# SERVICE LETTER

No. 751

Piper Aircraft Corporation

Fin Front Spar Modification.

SPAR TRIMMING DETAIL

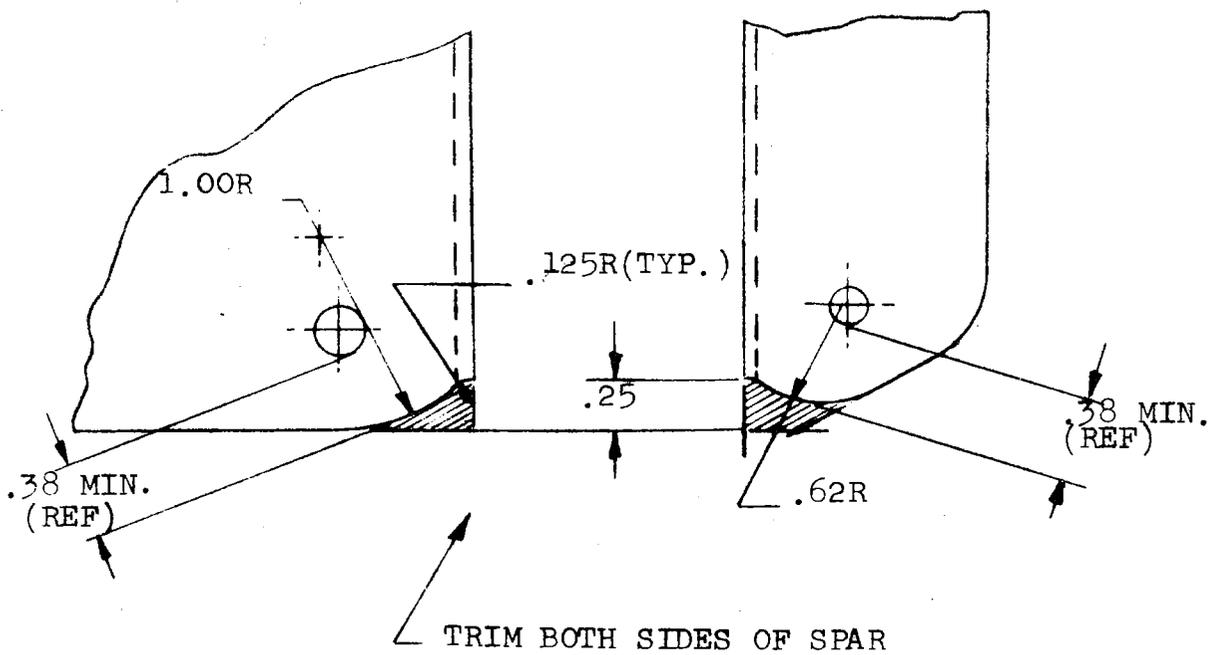
Currently, it is necessary to physically remove the fin to gain visual access to the channel relief holes, as the fin front spar extends over the relief holes by approximately 1/2 to 2/3 of the relief hole diameter.

To eliminate removal of the fin and to enable an easy visual inspection, the fin front spar may be modified in accordance with the sketch/instruction sheet contained on the reverse side of this release.

Refer to "Spar Trimming Detail" on reverse side of this release.
